工程指示 / 要求簡箋(E.I.)

工程指示編號：EI / 5213 / 22

工程名稱：將軍澳日出康城 11

工程項目：幕牆 防水片和基仔面防煙片 地盆用 (鉻化)

工程號	J858	類別		物料號	-		
地盘	康城11期	制圖	W. E. X	2022-08-11	圖號	FS-15	
修改	-	採用工廠			數量	-	
日期	-	材料颜色	CHROMATE		單件重量	-	
图纸名称	铝防水板加工图	復核	-				
材料	1.5mm THK. 铝板	批准	-

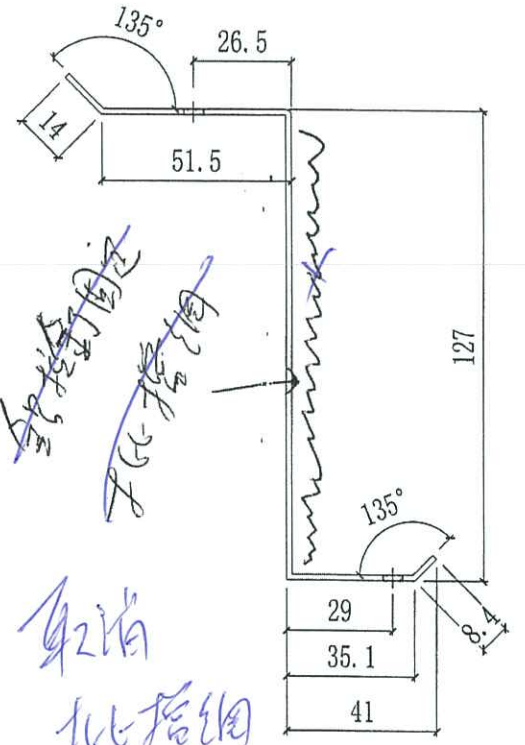
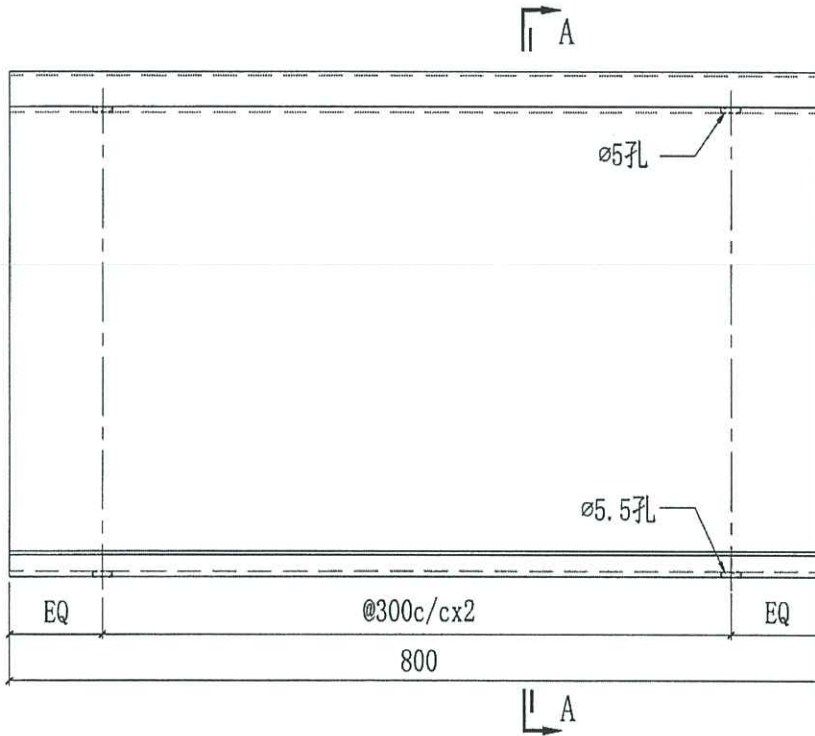
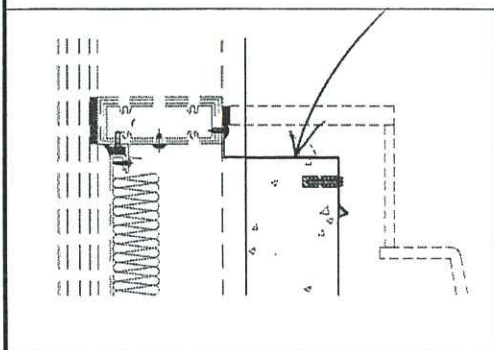
D 版: FS-15 浴室位不需批擋網。**C 版: 附上防水片出貨分批和包裝打紮方法(已和地盤夾好)。****隔火層 11/F,40/F, 特色層 獨立分座包扎 見後頁款式。****只放行生產 T1,2,3 的 9-17/F 和 18/F-21/F。****地盆：安裝樣板層時，請覆尺防水片能否按此理論數，出餘下大貨 B: 提供防水片分層****請按加工圖生產防水片送地盆， 所有防水片需鉻化****生統：防煙片需要批擋網****地盆/生統：鵝頭位獨立包裝，保持生產，待地盆通知出貨。****FS-11,FS-15 是 SmokeSeal 基仔面防煙片 優先生產和出貨**請在 **2022.11.12** 前完成上列要求。

現附上和泥水夾浴室收口, 防水片和收口疋的detail

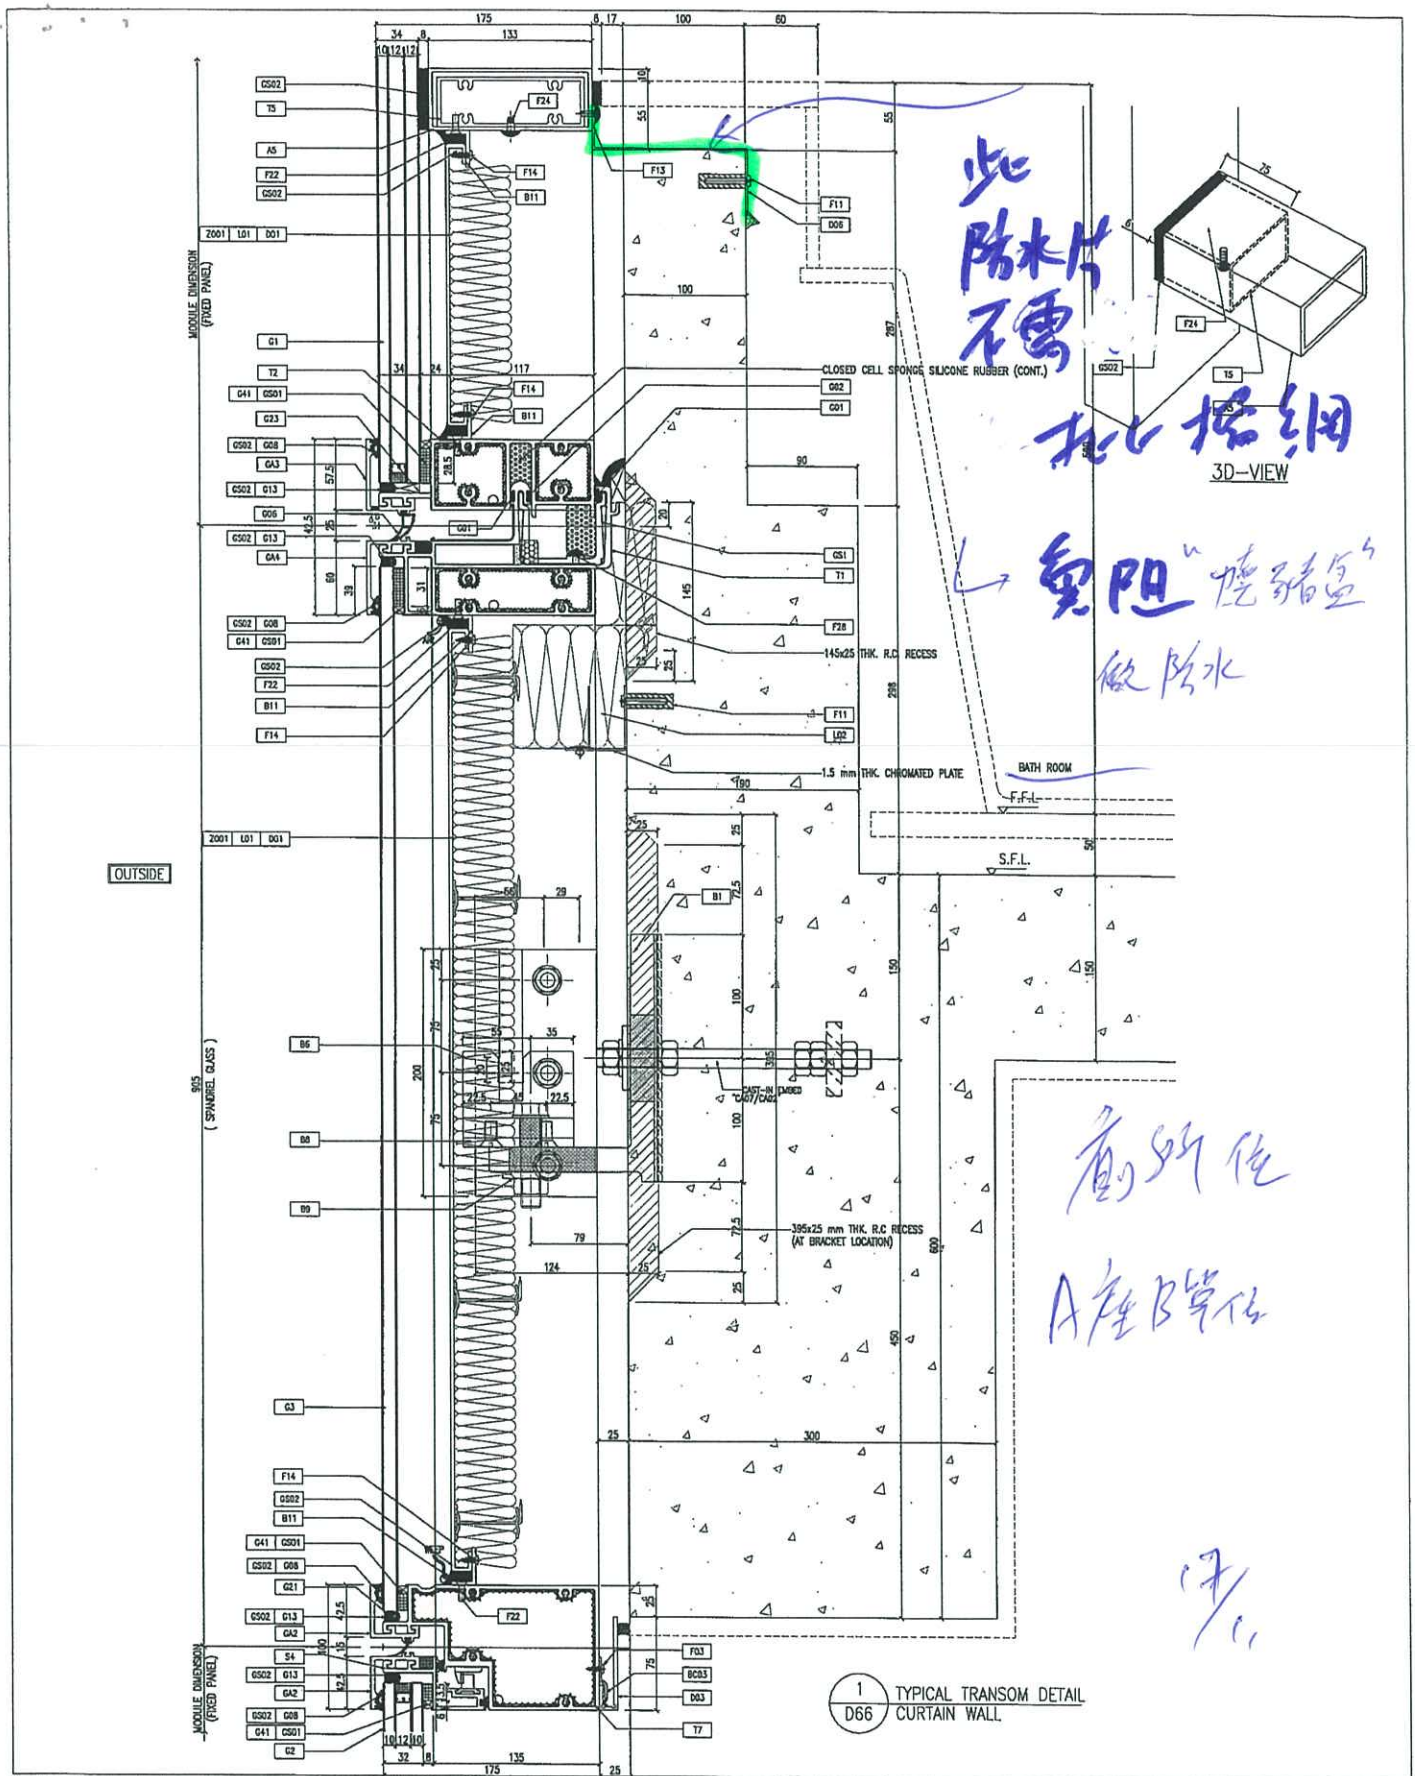
1. 橫向防水片不需批擋網。
2. 企向的收口疋為15mm 和不需額外第二重防水片。

1 TYPICAL TRANSOM DETAIL
D66 CURTAIN WALL

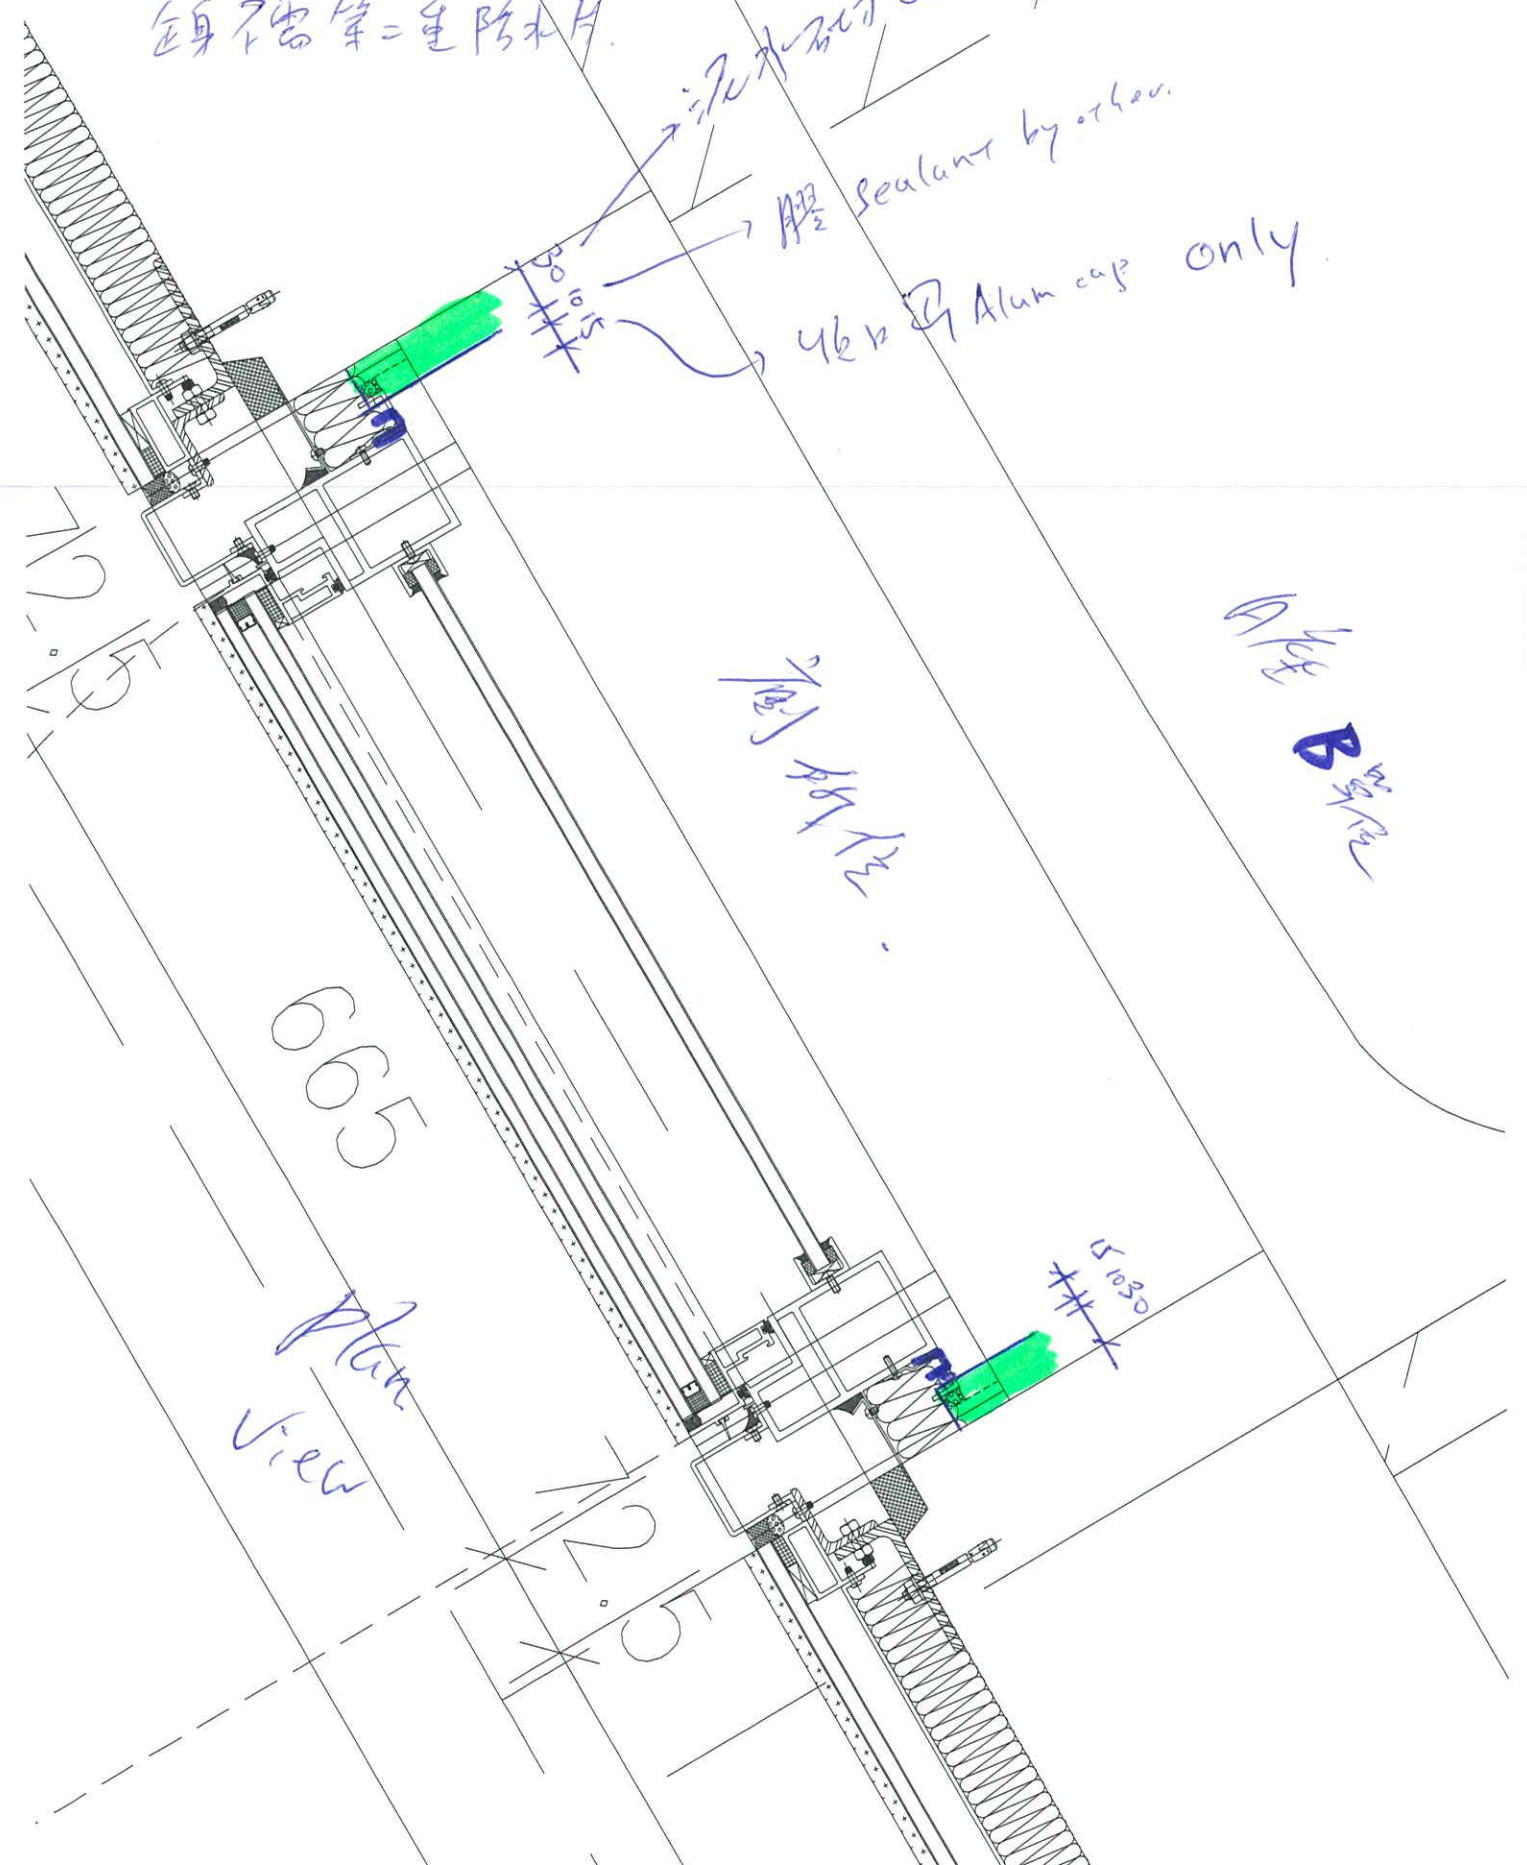
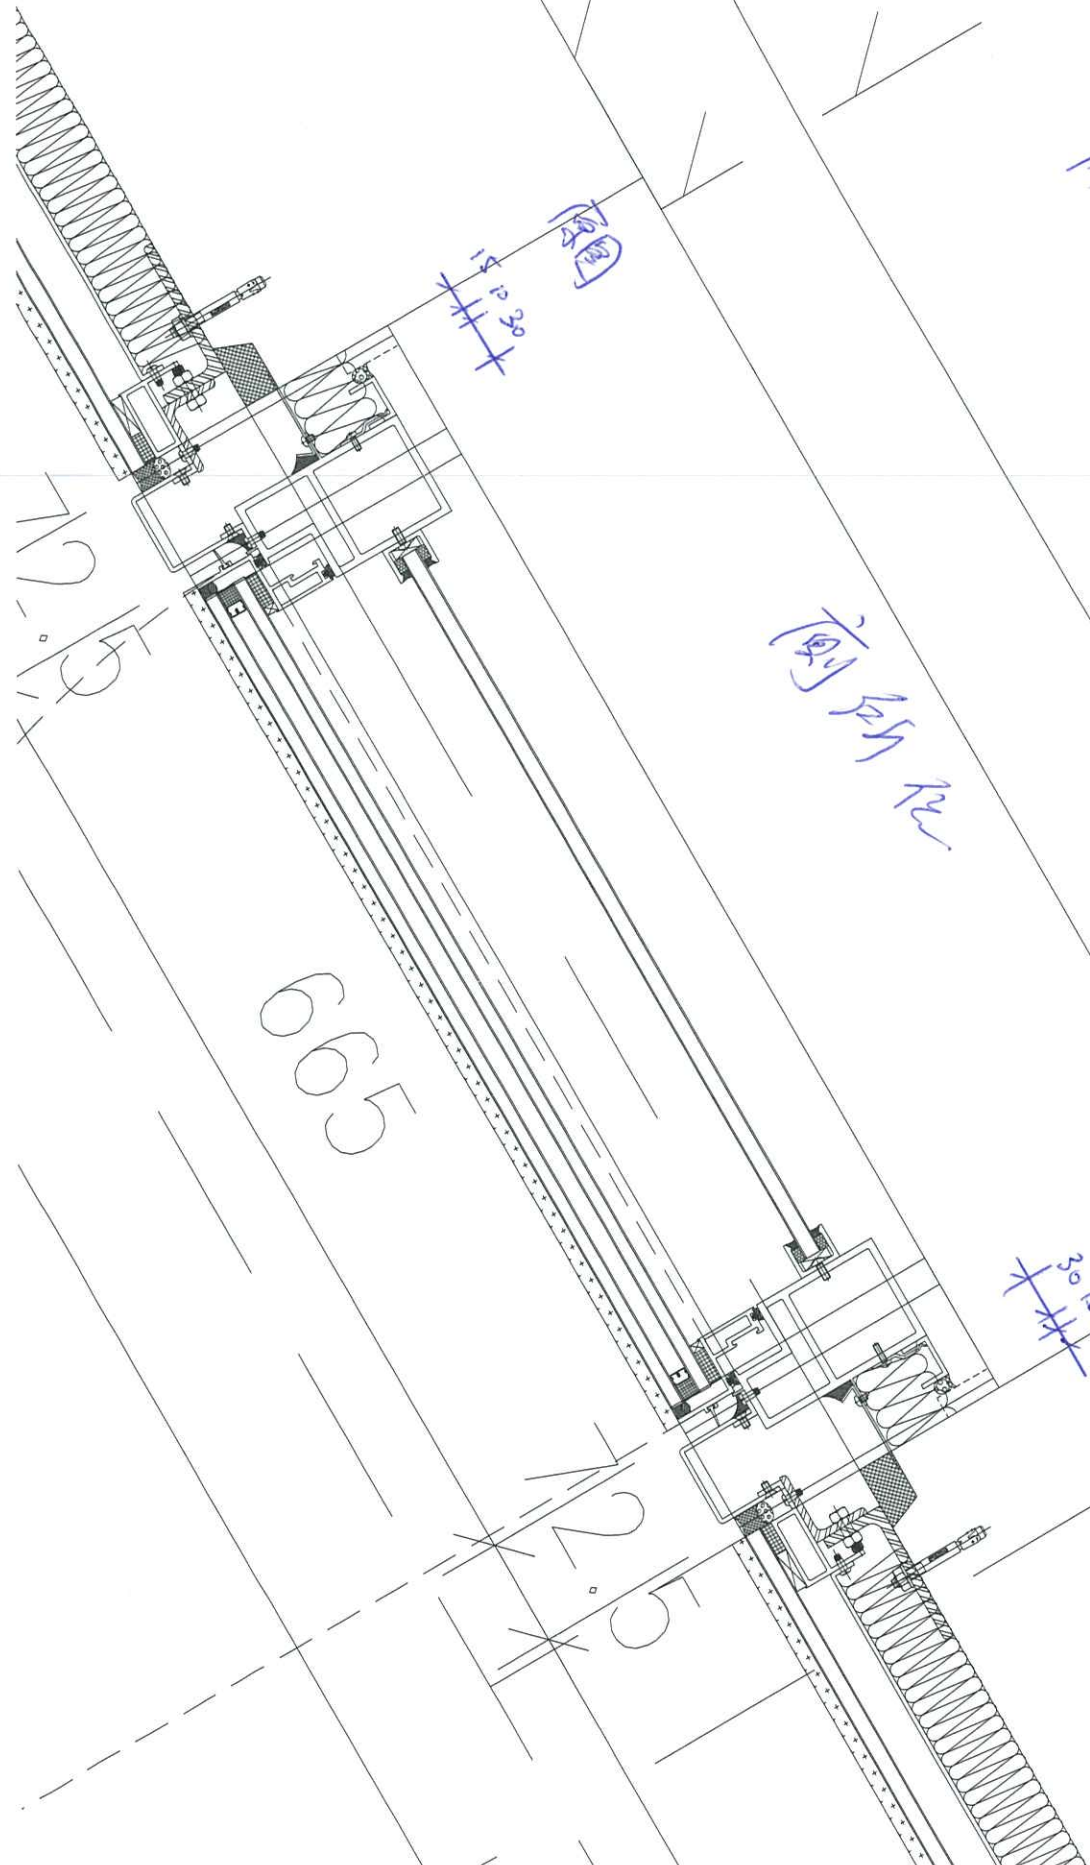
只本有 46b 的 only
全身不需等 = 重防木片.

泥水工 的 a
A32 Sealant by other.
46b 的 Alum cap only.
